Request for Qualifications

Solicitation Number: Q-15-001-DHS

Engineering Services for the 2015 Capital Improvement Program

ADDENDUM #1 – 10:00 AM Central | December 18, 2014

Exhibit 1:

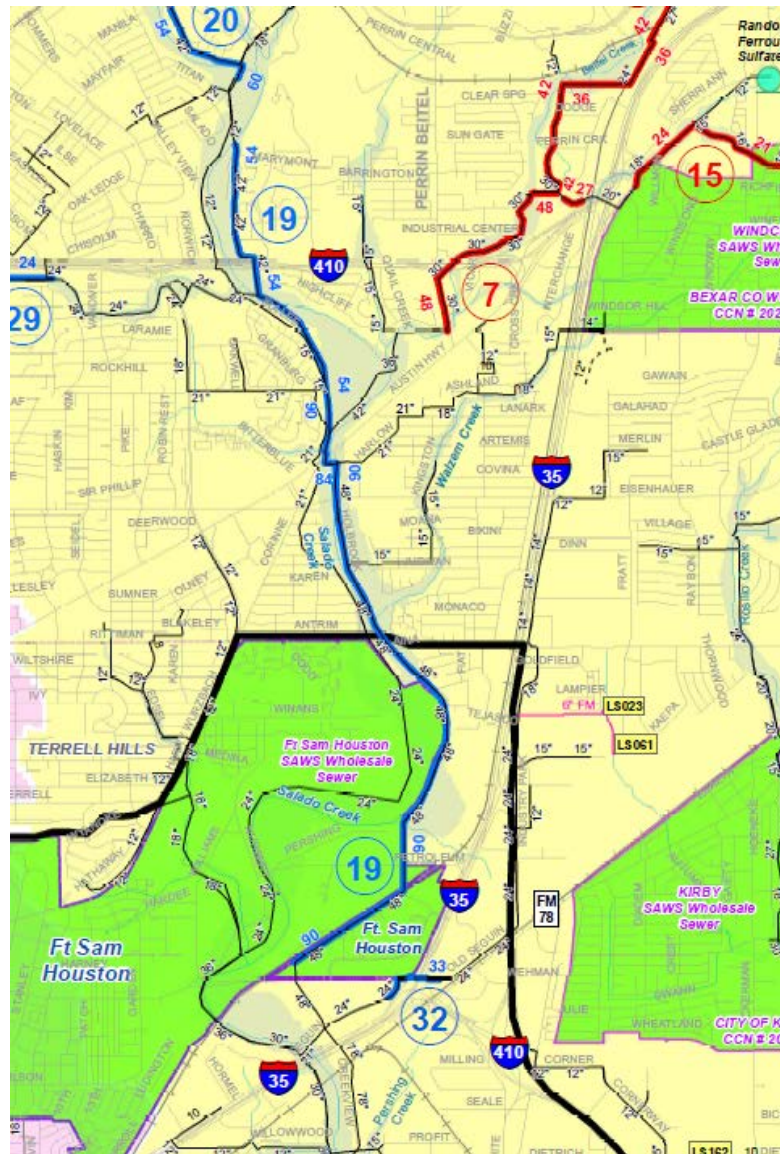
33. Can you please make available a figure with the existing alignment for E-19 Seguin to Nacogdoches; this will help the submitters in preparing their project approach and also level the playing field for all firms because some firms may already have this information.

35. With regards to E-19 Seguin to Nacogdoches, Does the alignment enter Fort Sam Houston? If the alignment can be made available, this question can be ignored.

Response: See number 19 on the exhibit below. This is generally the alignment but may change during the Phase A preliminary design process.

Response: Yes, see above exhibit.
